ROAD SAFETY AUDIT STAGE 1 / STAGE 2

MAY 2026

**NAVY BANK PROJECT AT
POINT ROAD, DUNDALK, CO.LOUTH**

**ROAD SAFETY AUDIT
STAGE 1 / STAGE 2**

2.1 PEDESTRIAN CROSSING OF POINT ROAD

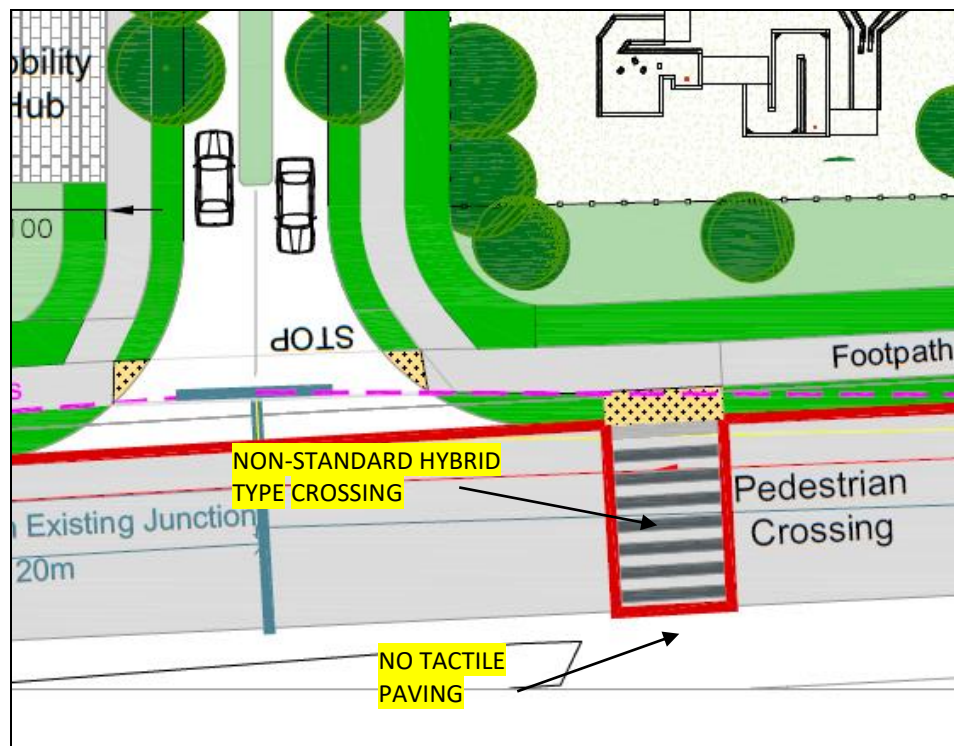
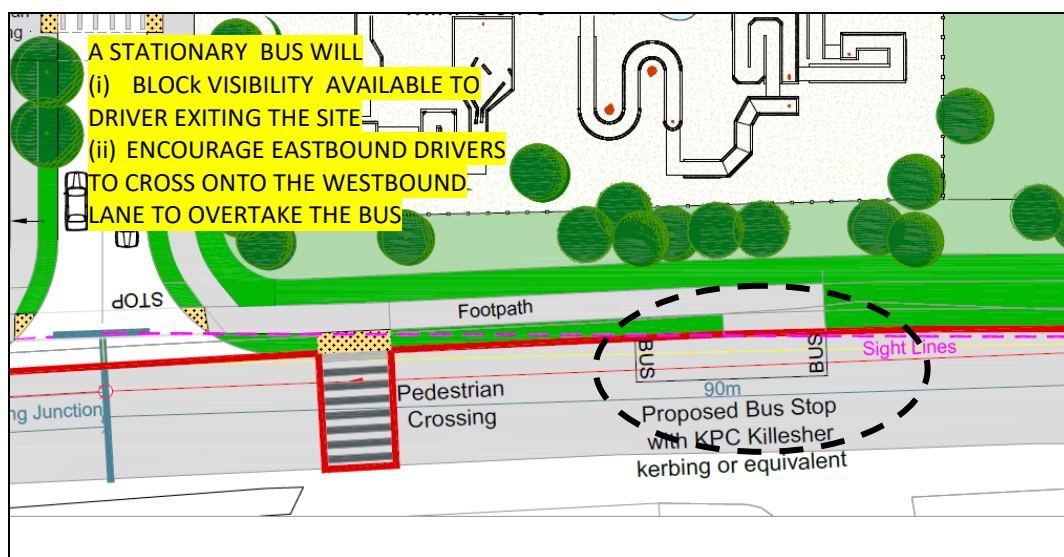
The crossing type as shown is a non-standard hybrid of a controlled and uncontrolled crossing.

If an uncontrolled crossing; then the provision of zebra stripes is non-standard

If a controlled zebra crossing; then either flashing belisha beacons or alternative signage as TSAN-2024-01 is required

The tactile configuration is incorrect for either case

Decide on appropriate crossing type (controlled or uncontrolled)

Apply correct design features for the selected crossing type.

If uncontrolled – omit zebra stripes

If controlled –select either a Type A or Type B configuration as per TSAN-2024-01 (

A Zebra Crossing Type A or Type B should only be installed in locations where 85% speed is < 50km/hr

Observations during the site visit would indicate operational speeds exceed this level

A speed survey would be required to 'prove' that a zebra crossing is appropriate.

If a controlled crossing is to be provided; a traffic light controlled crossing would represent a better choice.

Item Ref.	Identified Problem	Designers Response
2.1	Pedestrian Crossing of Point Road	Uncontrolled Crossing Point now provided with dropped kerb and tactile paving on each side of road Refer to Drg. No. LCC-NVY-DRG-3.0 (29/04/26)

2.2 BUS STOP

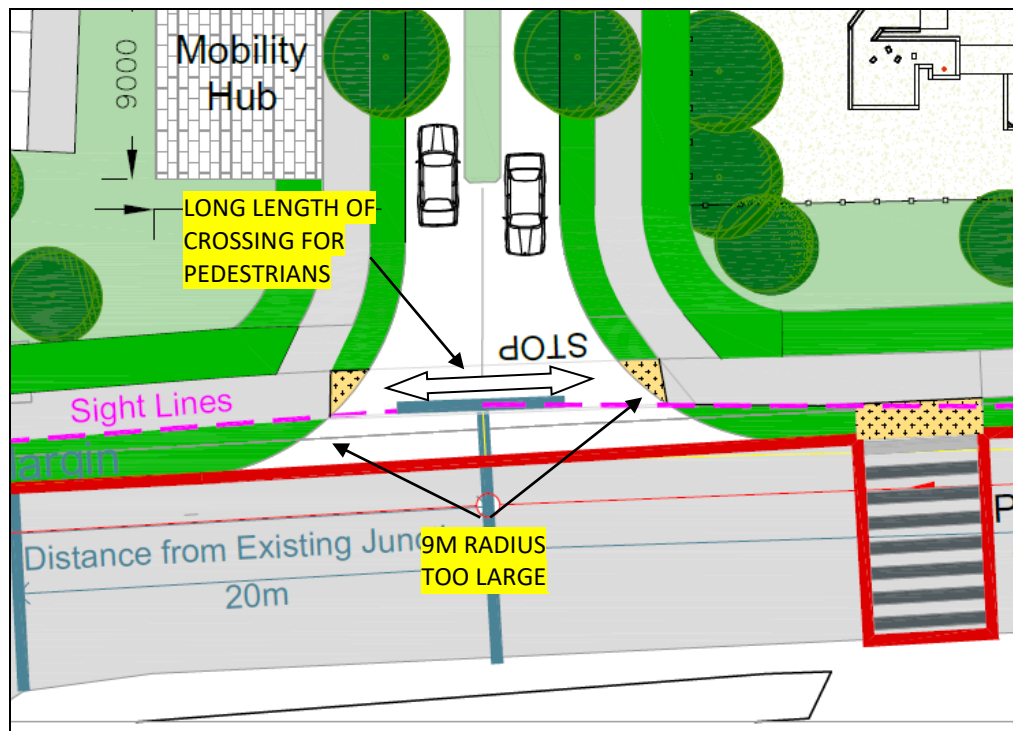
The 'on-line' Bus Stop configuration, with the bus stop occupying the east bound lane of the Point Road, is sub-optimum for the following reasons:

- (i) A parked bus will obstruct the required 49m x 2.4m visibility splay in this direction for drivers exiting the recreational facility.
- (ii) Drivers shall drive onto the opposing lane in order to 'pass' a stationary bus with resultant risk of collision with an oncoming vehicle.

Avail of the wide grass verge along the north side of the Point Road to create an 'off-line' bus stop or bus lay-by.

If this is not possible then shift the bus stop circa 10m to the east so that it lies outside of the 49m visibility splay

2.2	Bus Stop	On-line Bus Stop now replaced by a Bus Lay-by Refer to Drg. No. LCC-NVY-DRG-3.0 (29/04/26)
2.3	Site Entrance	Entry and Exit radius at entrance reduced at 4.5m Refer to Drg. No. LCC-NVY-DRG-3.0 (29/04/26)

2.4 INTERNAL ACCESS ROAD – CROSS SECTION

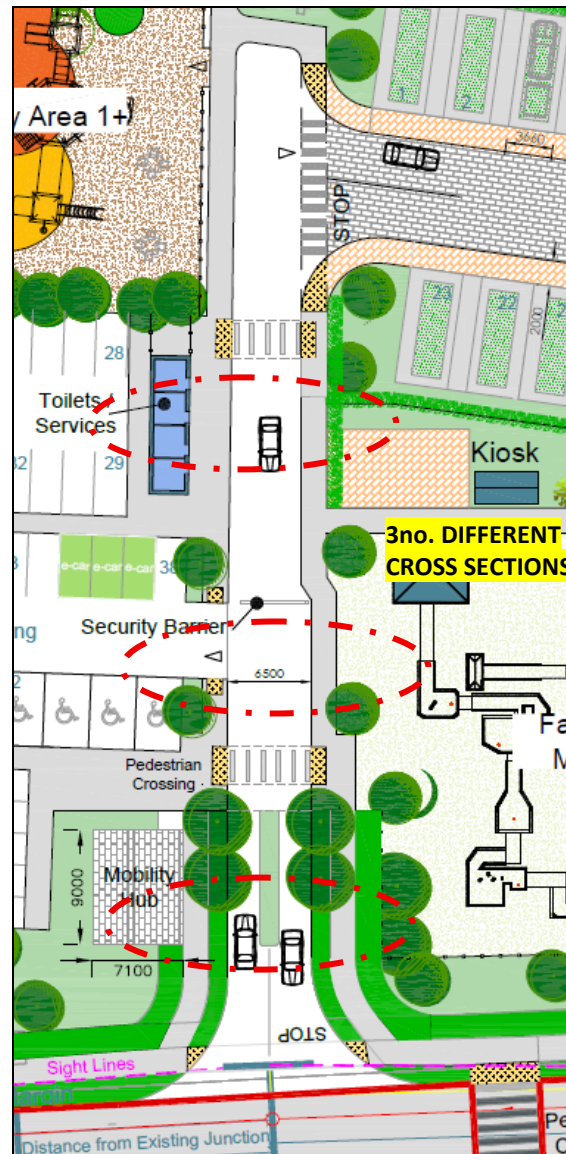
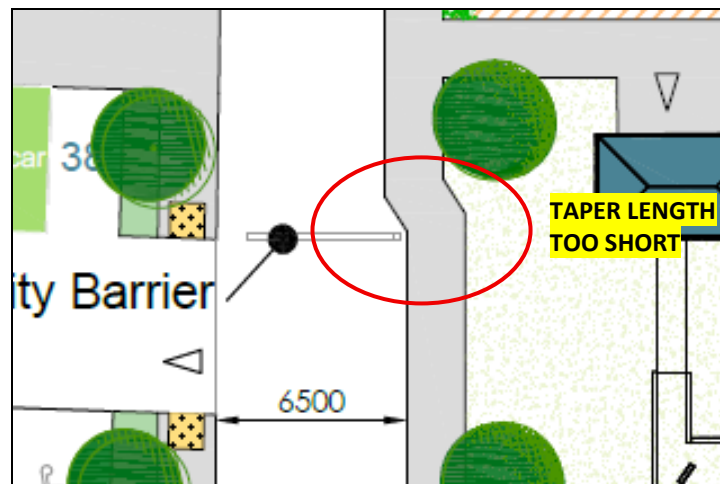
The site access road has a variable cross section with a mix of divided and undivided carriageways and a carriageway width switching from 6.5m to 5.5m.

The inconsistent cross section shall confuse drivers and lead to inconsistent driver behavior.

The 6.5m wide carriageway is inappropriate for a low speed environment

Retain a consistent road cross section/carriageway width along the entire length of the access road.

It is the view of the Audit Team that a 5.5m undivided carriageway represents the optimum choice.

2.4	Internal Access Road – Cross Section	Standard 5.5m wide undivided carriageway cross section provided along the entire length of the Access Road. Refer to Drg. No. LCC-NVY-DRG-3.0 (29/04/26)

2.5 ROAD WIDTH TRANSITION / TAPER LENGTH

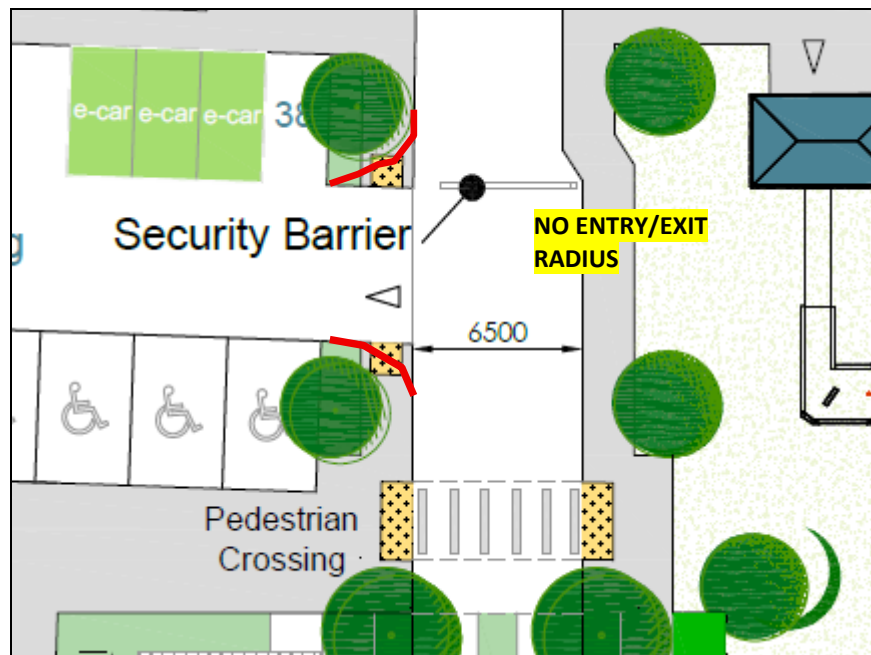
The proposed transition between a 6.5m carriageway width to a 5.5m carriageway width occurs over too short a taper (1m)

Drivers shall not be able to adjust their line of travel within this short distance

Taper should be at least 5m long (1 in 5 taper)

Audit Team Note: The recommended selection of a consistent carriageway width (Item 2.4) shall eliminate this problem.

2.5	Road Width Transition/Taper Length	Design Response to Item 2.4 eliminates need for taper Refer to Drg. No. LCC-NVY-DRG-3.0 (29/04/26)
2.6	Car Park Entrance	Entry / exit radius now provided at car park entrance Refer to Drg. No. LCC-NVY-DRG-3.0 (29/04/26)

2.6 CAR PARK ENTRANCE

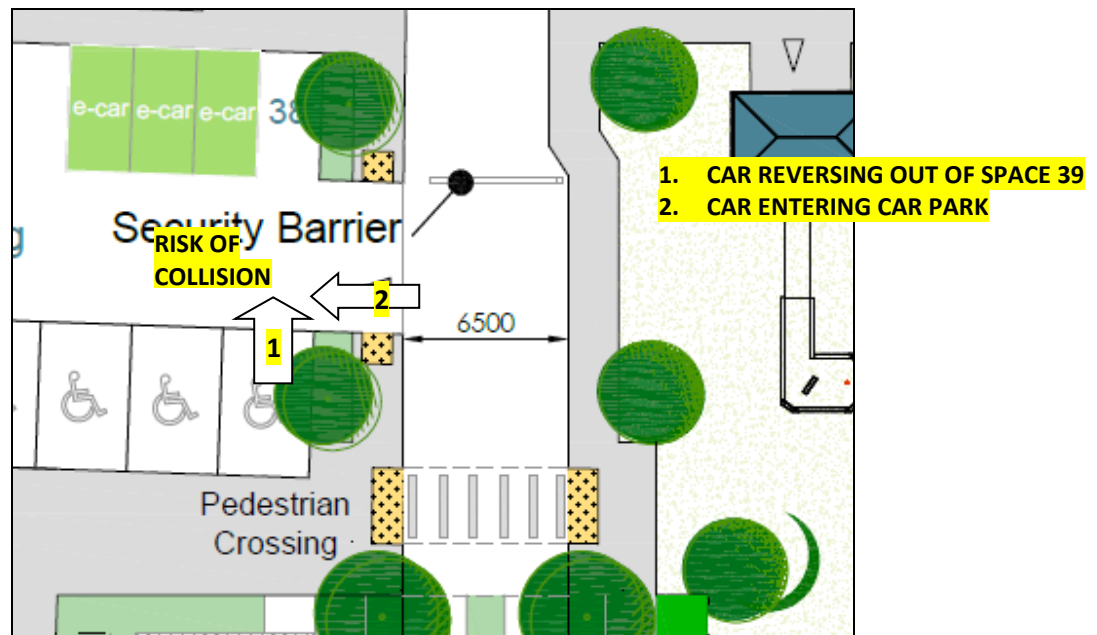
No entry /exit turning radius are provided at the car park entrance.

Drivers entering the car park will have to encroach onto the car park exit lane in order to enter the car park with resulting risk of a collision between a car entering and a car waiting to exit the car park

Provide entry and exit radius of 2m – 3m

2.7 PROXIMITY OF PARKING SPACES TO CAR PARK ENTRANCE

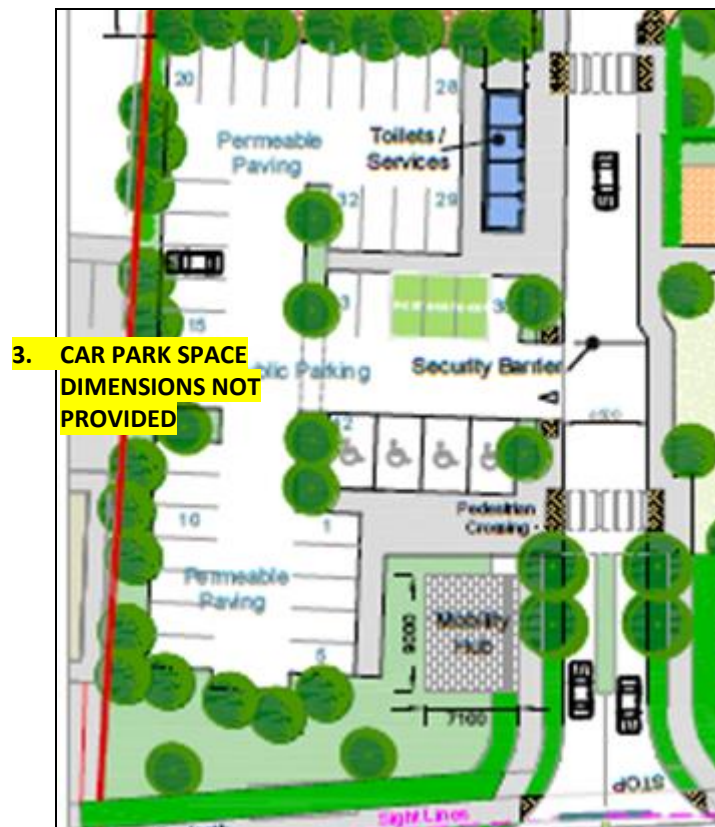
Car park spaces 38 and 39 are located within 3m of the car park entrance/exit.

There is a resulting high possibility of a collision between a vehicle reversing into/out of these spaces and a vehicle entering/exiting the car park.

Omit car park spaces 38 and 39 and replace with small landscape areas/bioretention areas

2.7	Proximity of Car Park Spaces to Car Park Entrance	Car Park Spaces 38 & 39 now omitted and replaced by landscape area Refer to Drg. No. LCC-NVY-DRG-3.0 (29/04/26)

2.8 CAR PARK SPACES – DIMENSIONS

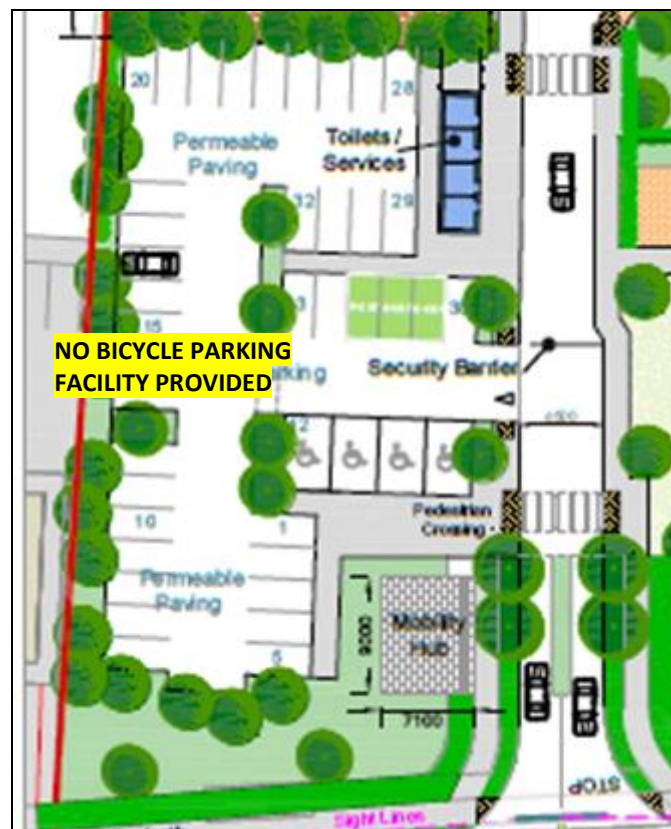
No dimensions are provided for the width or depth of the car parking spaces (standard, e-charging and mobility impaired type). It was not possible to accurately determine the dimensions by scaling off the design drawing.

It is therefore not possible to confirm whether the dimensions comply with the design standards set out in Table 13.9 of the Louth County Development Plan 2021-2027.

Ensure that all parking space types have the appropriate dimensions

2.8	Car Park Spaces - Dimensions	All car park spaces comply with standards set out in Table 13.9 of the LCDP 2021-2027 Refer to Drg. No. LCC-NVY-DRG-3.0 (29/04/26)

2.9 BICYCLE PARKING

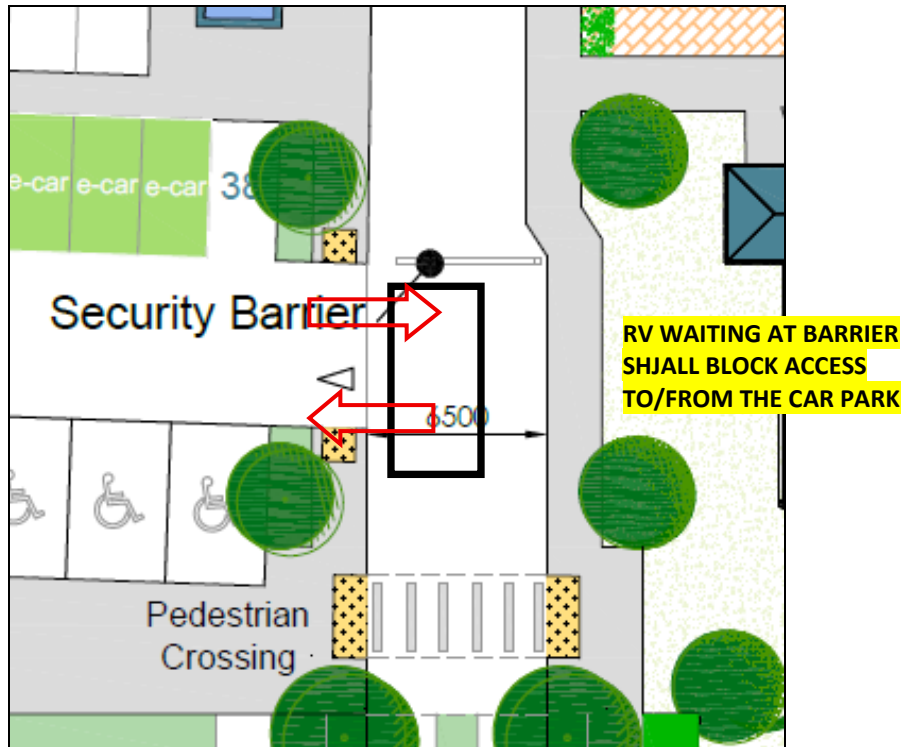
No facility is shown on the design drawing for bicycle parking.

It is Louth Co. Co policy to promote active travel and it is considered that a significant number of persons shall cycle to the facility.

The absence of a cycle parking area shall result in cyclists parking their bike in haphazard fashion and in inappropriate areas blocking pedestrian routes and being a trip hazard

Provide a cycle parking facility is provided within the site.

2.9	Bicycle Parking	Designated bicycle parking area now provided within car park area Refer to Drg. No. LCC-NVY-DRG-3.0 (29/04/26)
2.10	Access Barrier to RV Area	Access Barrier re-located to avoid clash with car park entrance Refer to Drg. No. LCC-NVY-DRG-3.0 (29/04/26)

2.11 ENTRANCE TO RV PARKING AREA

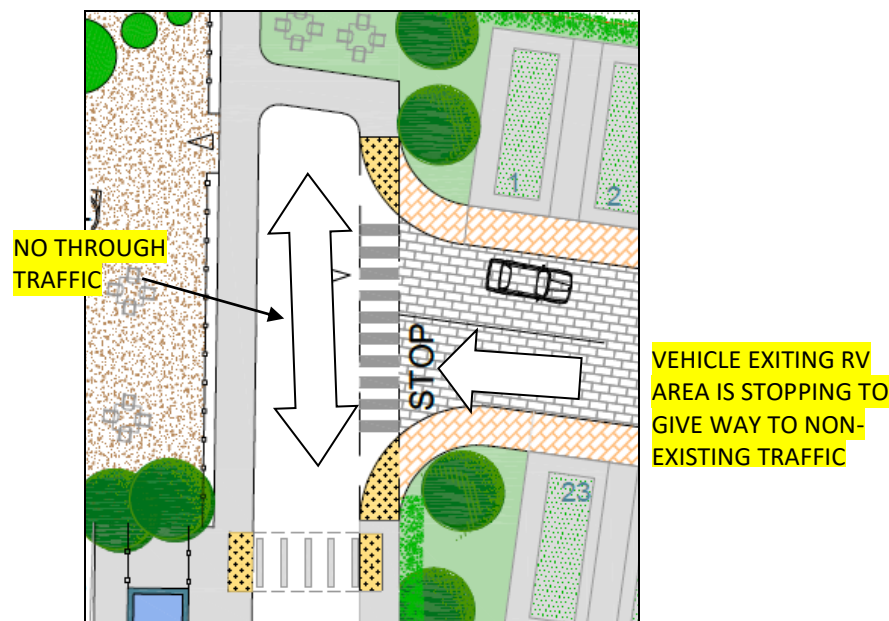
The entrance configuration matches that of a non-priority T type between a main road and a minor road. In this case the main road is the Site Access Road and the minor road is the RV Access Road.

The protocol at a simple priority junction is for minor road traffic to stop at the junction and wait for a gap in main road traffic before proceeding to turn onto the main road.

However, this protocol is not applicable in this case as the main road terminates immediately after the junction (i.e. no through traffic) while the traffic flow is exclusively between the access road (main road) and the RV access road (minor road).

In other words, the current configuration creates an ineffective T junction with traffic entering/exiting the RV parking area required to give way to non-existent traffic on the main access road.

Drivers shall, under these circumstances, fail to follow the standard T junction protocol and shall instead enter/exit the RV area in a continuous movement with no stopping

The junction entry/exit turning radius (6m) is not large enough to cater for this 90° turning movement except at very low speeds. There is a risk of a RV overturn if a driver attempts to make this turn at too high a speed.

Omit the T junction entrance to the RV Parking Area.

Link the main access road and the RV parking access road with a small radius horizontal curve to provide a direct route into/out of the RV Parking Area .

Ensure that the radius of the horizontal bend is large enough for the driver of a RV to negotiate without undue steering effort when travelling at an appropriate speed (20km/hr) – i.e. min. radius (centreline) to be 13m.

2.11	Entrance to RV Parking Area	T-Junction configuration now replaced, Main Access road now links to RV access road via short horizontal bend (R = 13m) Refer to Drg. No. LCC-NVY-DRG-3.0 (29/04/26)

2.12 RV PARKING – CARRIAGEWAY WIDTH

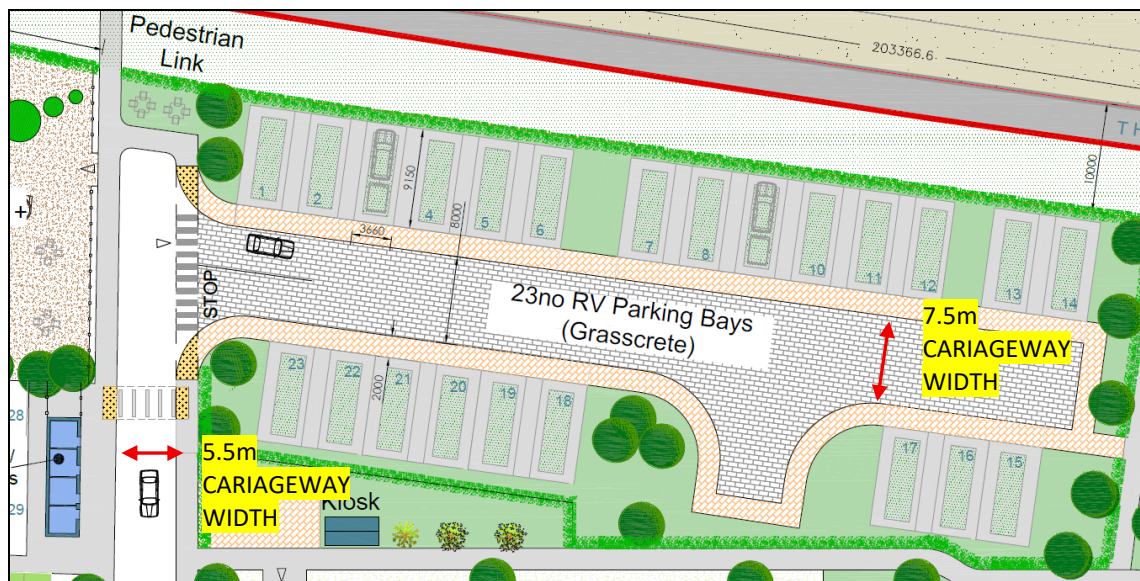
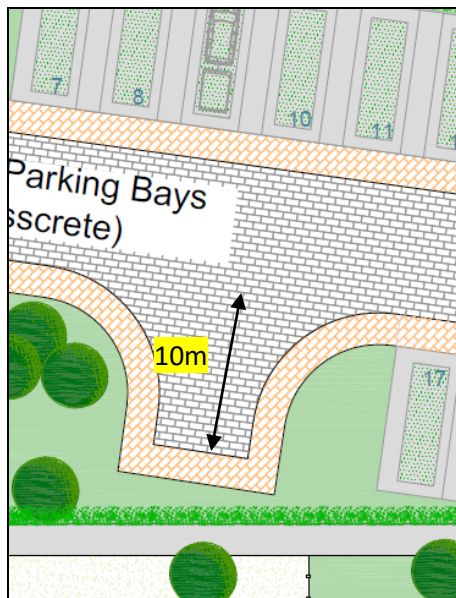
It is not clear why carriageway width within the RV parking area is 7.5m in comparison to the 5.5m width of the main access road.

The use of inconsistent carriageway widths throughout the same development is poor design and will confuse drivers.

The 7.5m carriageway width shall encourage inappropriate high speeds along this section of road.

Reduce the carriageway width to 5.5m to offer consistency with the remaining sections of the access road.

It may be that the 7.5m width has been provided to provide sufficient road width to allow a RV reverse into/out of the parking bay. If this is the case; then increase the depth of each parking bay by 1m and run a 1m buffer strip along the front of each parking bay to compensate for the loss of reversing space due to reducing the carriageway width to 5.5m

Audit Team Comment - the value of running a footpath along both sides of the RV Access Road is questionable given that each footpath shall require dropped kerbing along its entire length to allow a RV access a parking area.
The need for a footpath along both sides of the RV access road should be re-assessed given the low traffic volume within this enclosed area

2.12	Carriageway Width – RV Parking	Carriageway width reduced to 5.5m 1.0m buffer zone provided in front of each RV parking bay Refer to Drg. No. LCC-NVY-DRG-3.0 (29/04/26)
2.13	Turning Head – RV Parking Area	Type (i) turning head now provided at eastern end of RV Access Road R Refer to Drg. No. LCC-NVY-DRG-3.0 (29/04/26)
2.14	Public Lighting	A detailed Public Lighting Design Proposal shall be prepared at the detailed design stage

2.13 TURNING HEAD WITHIN THE RV PARKING AREA

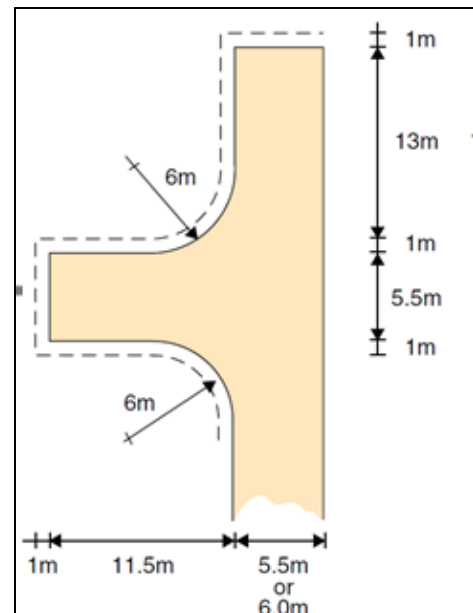
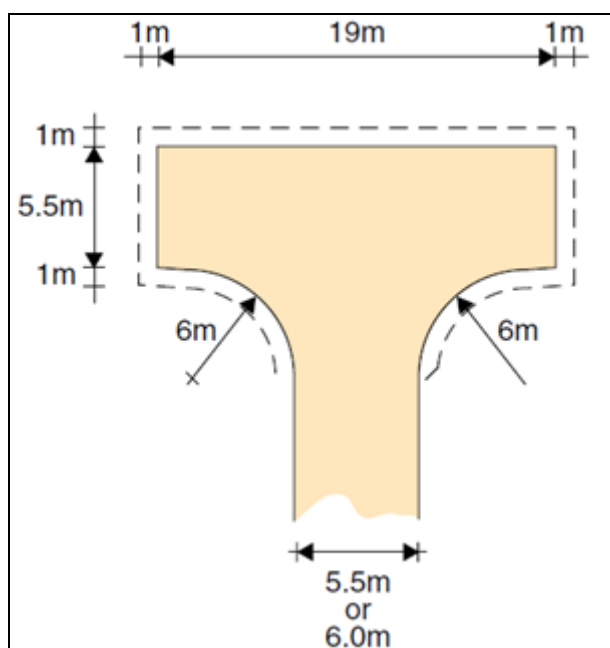
The turning bay as shown is a non-standard variant of Turning Head Type (ii). In particular, the depth (10m) of the turning arm is too short to accommodate the turning movement of a large vehicle (including a RV)

- (i) Increase depth of the turning head to 11.5m , or
- (ii) Consider an alternative option of providing a Type (i) Turning Head at the east end of the RV access road
